Subject: CUP14-00015  
1173 W. University Dr.  
Request to construct a new Alumni Center.

**Project/File: CUP12-00046**

This is a conditional-use application to construct a 46,627 square foot events center and alumni office for Boise State University. The site is located at 1173 W. University Drive in Boise, Idaho.

**E1** SITE PLAN  
1" = 20'-0"

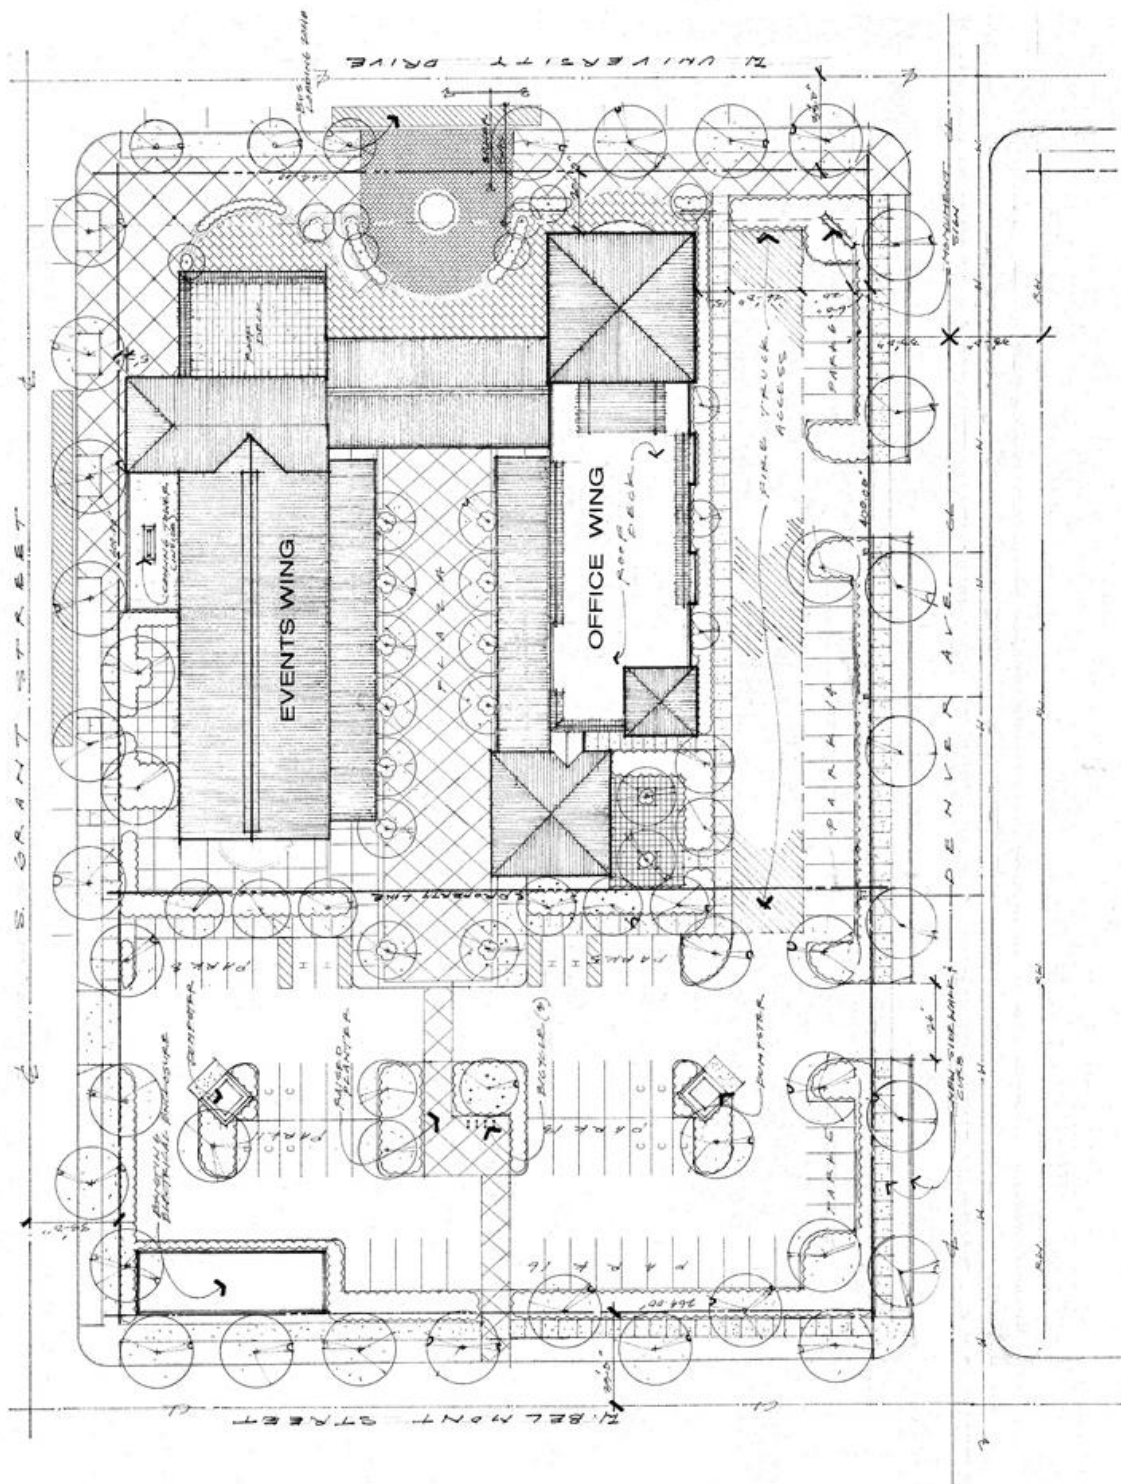
- c. **Applicant's Proposal:** The applicant is proposing to construct Belmont Street as one-half of a 36-foot street section with vertical curb, gutter, and 5-foot wide attached sidewalk abutting the site.
- d. **Staff Comments/Recommendations:** The applicant's proposal meets District Street Section Policy and should be approved, as proposed. The applicant should provide the District with a permanent right-of-way easement for any portion of the sidewalk located outside of the right-of-way.

- c. **Applicant's Proposal:** The applicant is proposing to construct Grant Avenue as one-half of a 36-foot street section with vertical curb, gutter, and 5-foot wide attached sidewalk abutting the site.
- d. **Staff Comments/Recommendations:** The applicant's proposal meets District Street Section Policy and should be approved, as proposed. The applicant should provide the District with a permanent right-of-way easement for any portion of the sidewalk located outside of the right-of-way.

- c. **Applicant's Proposal:** The applicant is proposing to close all 3 driveways and replace them with curb, gutter, and 5-foot wide detached sidewalk.
- d. **Staff Comments/Recommendations:** The applicant's proposal meets District Driveway Policy and should be approved, as proposed.

- c. **Applicant's Proposal:** The applicant is not proposing any changes to the 28-foot wide driveway onto Denver Avenue located 150 feet south of the intersection of Denver Avenue and University Drive.

The applicant is proposing to construct a 26-foot wide driveway onto Denver Avenue located 135 feet north of the intersection of Denver Avenue and Belmont Street.

**c. Applicant's Proposal:** The applicant is proposing to close the 5 driveways and replace them with curb, gutter, and 5-foot wide detached sidewalk.

The applicant is proposing to construct one 26-foot wide driveway located approximately 135 feet north of the intersection of Grant Avenue and Belmont Street (measured centerline-to-centerline).

1. Construct Belmont Street as one-half of a 36-foot street section with vertical curb, gutter, and 5-foot wide attached concrete sidewalk abutting the site.
2. Construct Denver Avenue as one-half of a 36-foot street section with vertical curb, gutter, and 5-foot wide attached concrete sidewalk abutting the site.
3. Construct Grant Avenue as one-half of a 36-foot street section with vertical curb, gutter, and 5-foot wide attached concrete sidewalk abutting the site.

4. Provide the District with a permanent right-of-way easement for any portion of sidewalk located outside of the right-of-way.
5. Correct any deficiencies and/or replace deteriorated facilities abutting the site, including sidewalk construction or replacement; curb and gutter construction or replacement; installation or reconstruction of pedestrian ramps; pavement repairs; signs; traffic control devices; and other similar items, abutting the site.

6. Replace the following driveways onto Belmont Street with vertical curb, gutter, and 5-foot wide detached concrete sidewalk to match the required improvements on either side:

8. Replace the following driveways onto Grant Avenue with vertical curb, gutter, and 5-foot wide detached concrete sidewalk to match the required improvements on either side:

10. Direct lot access is prohibited to University Drive.
11. Payment of impacts fees are due prior to issuance of a building permit.
12. Comply with all Standard Conditions of Approval.
